**STAFF RECOMMENDATION**  
**1800 Holly Street**  
**December 16, 2015**

**Application:** New construction—addition  
**District:** Lockeland Springs-East End Neighborhood Conservation Zoning Overlay  
**Council District:** 06  
**Map and Parcel Number:** 08314006300  
**Applicant:** Kim Kennedy, Bootstrap Architecture  
**Project Lead:** Melissa Baldock, melissa.baldock@nashville.gov

<p><b>Description of Project:</b> The applicant proposes to construct a side and rear addition.</p> <p><b>Recommendation Summary:</b> Staff recommends approval of the project with the condition that staff approve the final details, dimensions and materials of windows and doors prior to purchase and installation. With this condition, staff finds that the project meets Section II.B. of the <i>Lockeland Springs-East End Neighborhood Conservation District: Handbook and Design Guidelines</i>.</p>	<p><b>Attachments</b> <b>A:</b> Site Plan <b>B:</b> Elevations</p>
--	--

Figure 3. The addition will attach to the rear section of the house, which is inset and has a separate roof form from the primary portion of the house.

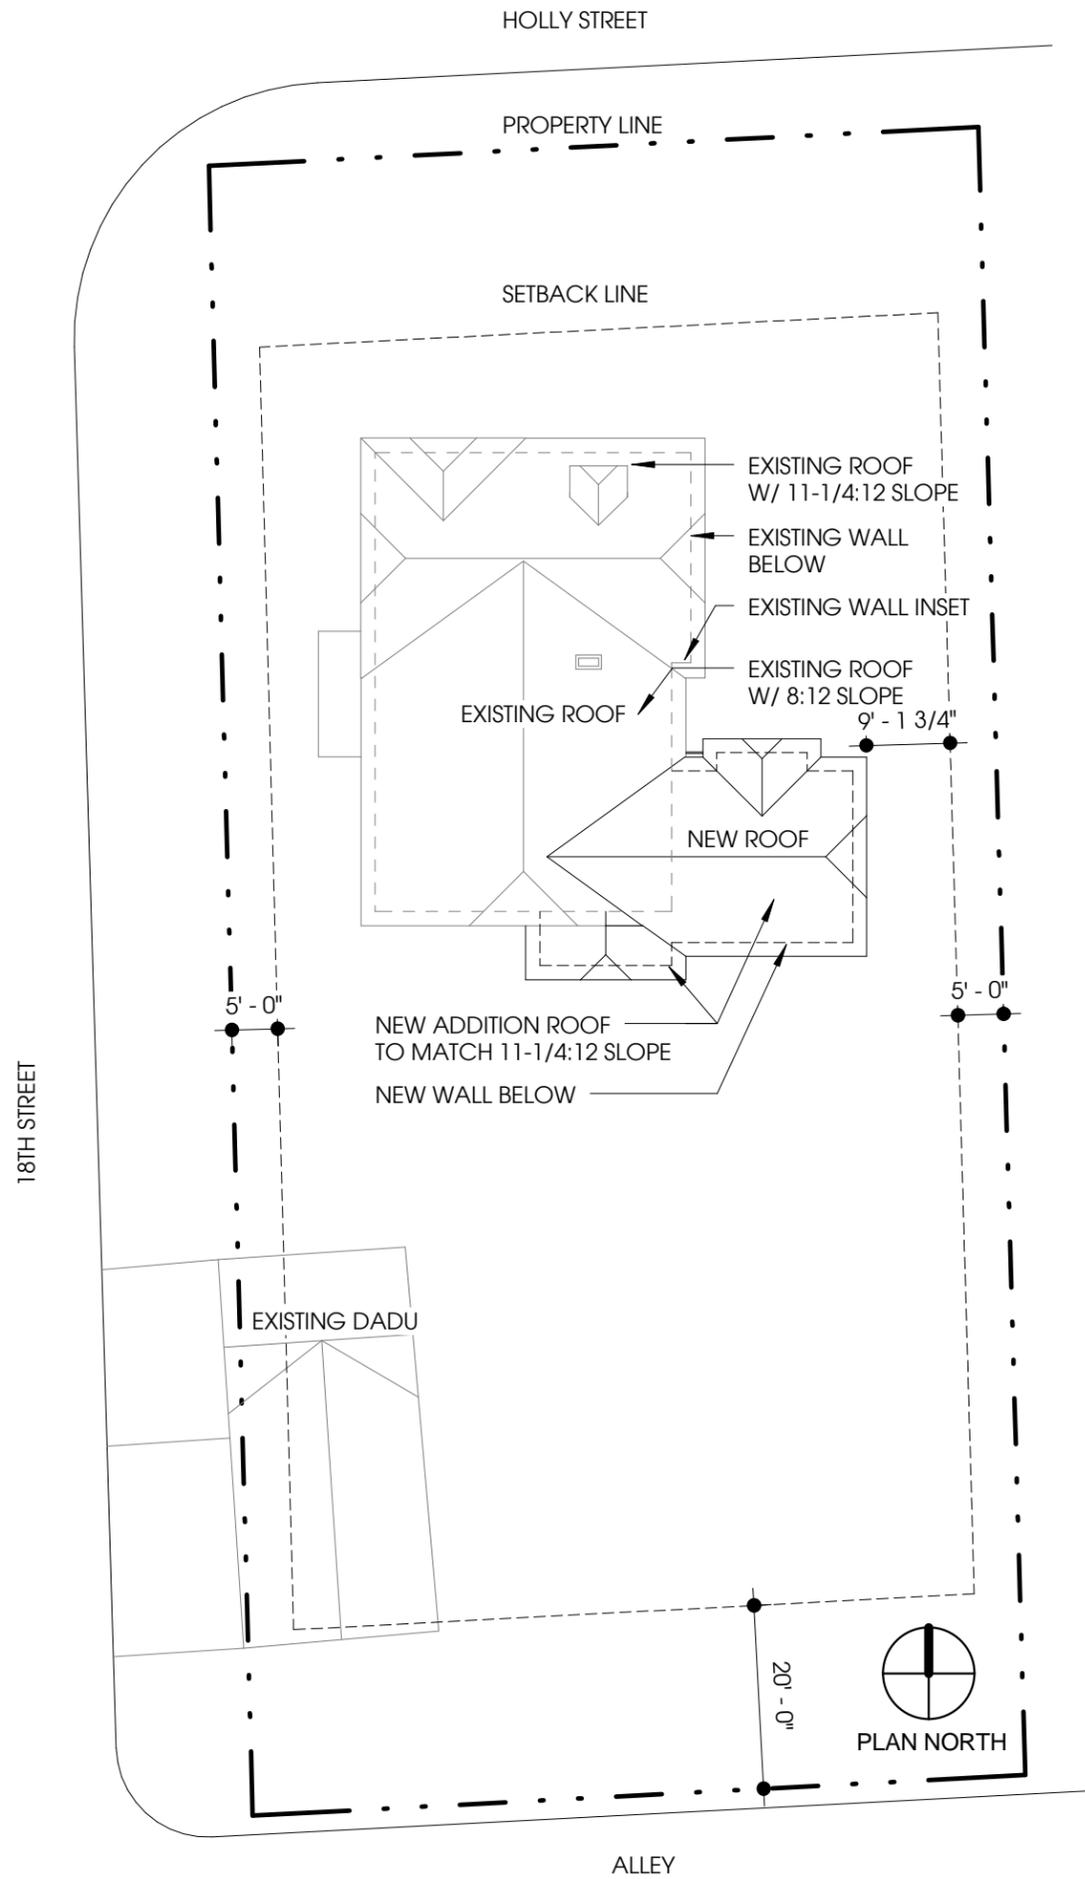
wide, on a block where lots are typically fifty feet (50') wide. The side addition will be located towards the rear of the house, and is approximately two feet (2') shorter than the historic house. The historic house is thirty-four feet (34') wide, and the side addition will extend seventeen feet (17') beyond the side wall of the house. The addition's hipped roof with clipped forms mimics the historic house's roof. The addition does wrap the back corner of the existing structure. However, it attaches to a portion of the house that is inset, has a separate roof form, and that reads as an addition, and staff finds the design to be appropriate (Figure 3).

**H0.1**

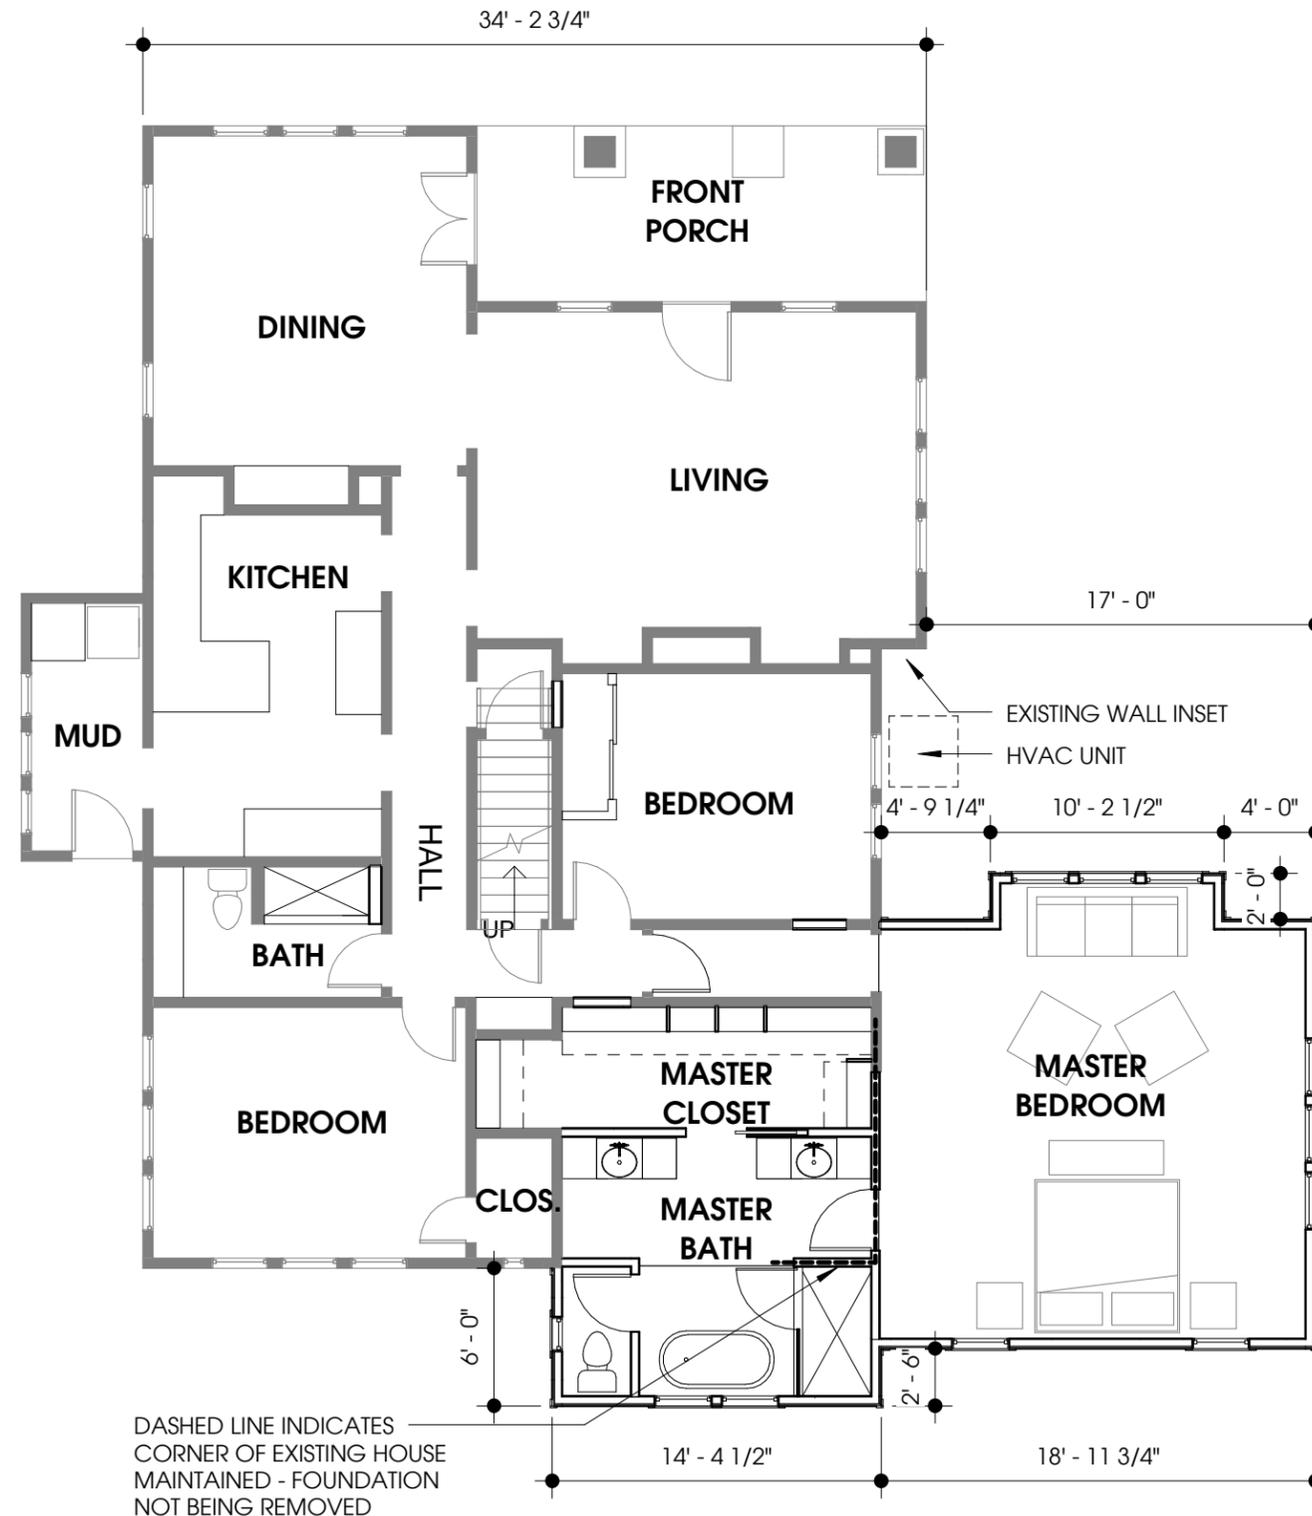
**Setback & Rhythm of Spacing:** The addition meets all base zoning setbacks. It will be over fourteen feet from the side property line, and will be over eighty feet (80') from the rear property line. The addition will not interrupt the rhythm of spacing along the street because the lot is so wide and because the addition is located beyond the midpoint of the historic house. Staff finds that the addition's setback and rhythm of spacing meet Sections II.B.3. and II.B.10. of the design guidelines.

Appurtenances & Utilities: No changes to the site's appurtenances were indicated on the drawings. The location of the HVAC and other utilities will remain in its current location, which is on the left side façade, at about the midpoint of the house, behind the inset.

**H1.1**

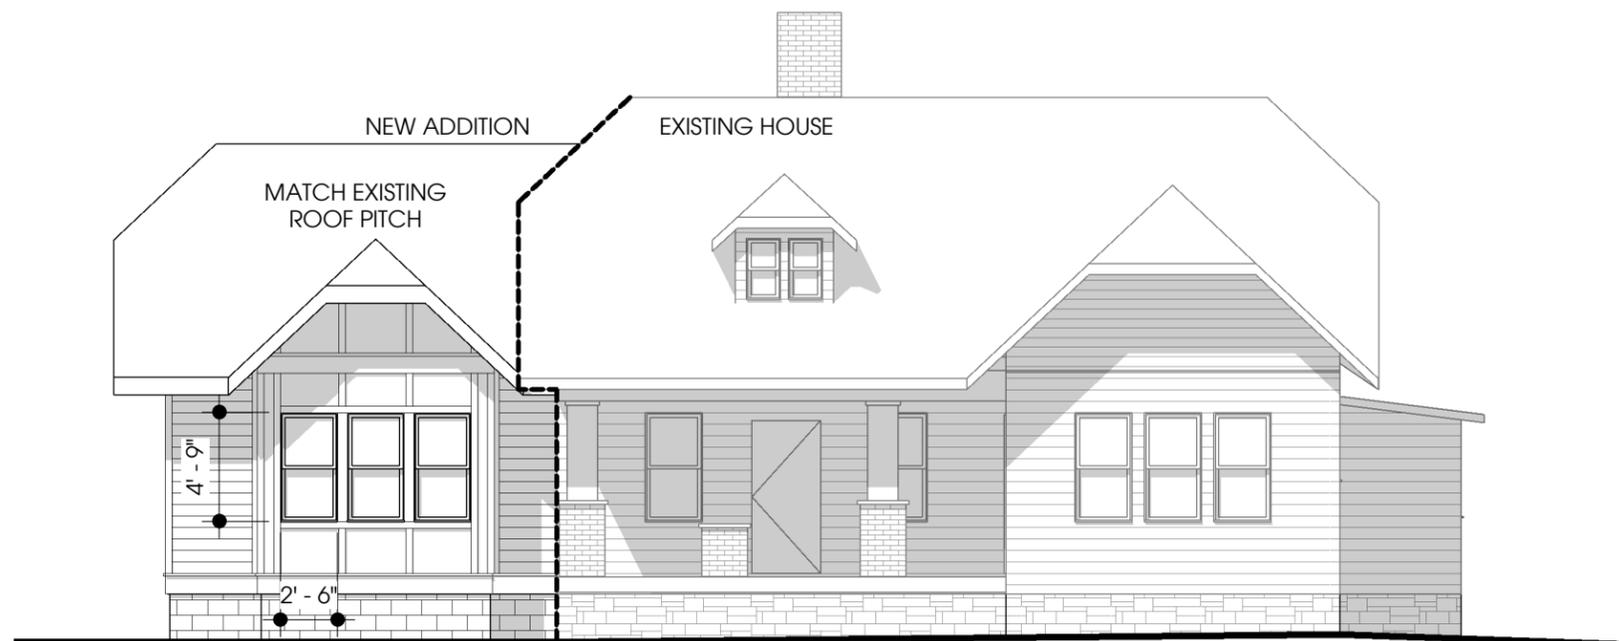
**Location & Removability:** The addition will be located to the side of the existing house, towards the rear. The design guidelines state that side additions can be appropriate if the lot is wider than sixty feet (60'), the addition is located beyond the midpoint of the house, and is subordinate in height and scale to the historic house. Staff finds that the proposed addition meets all of the guidelines for side additions. The lot is seventy-five feet (75')

**Height & Scale:** As previously mentioned, the addition will be two feet (2') shorter than the historic house. Its eave height and foundation height will match those of the historic house. The addition will extend seventeen feet (17') beyond the wall of the historic house, which is appropriate. The rear portion of the addition will be six feet (6') deep and approximately fourteen feet, five inches (14'5") wide. Staff finds that the proposed height and scale meet Section II.B.1., II.B.2., and II.B.10. of the design guidelines.

Proportion and Rhythm of Openings: No changes to the window and door openings on the existing house were indicated on the plans. On the front façade, the existing semi-circular window in the gable area isn't shown on the plans, but the applicant has confirmed that the window will not be altered as part of the project. The windows on the proposed addition are all generally twice as tall as they are wide, thereby meeting the historic proportions of openings. There are no large expanses of wall space without a window or door opening. Staff finds the project's proportion and rhythm of openings meet Sections II.B.7. and II.B.10. of the design guidelines.

**Recommendation Summary:** Staff recommends approval of the project with the condition that staff approve the final details, dimensions and materials of windows and doors prior to purchase and installation. With this condition, staff finds that the project meets Section II.B. of the *Lockeland Springs-East End Neighborhood Conservation District: Handbook and Design Guidelines*.
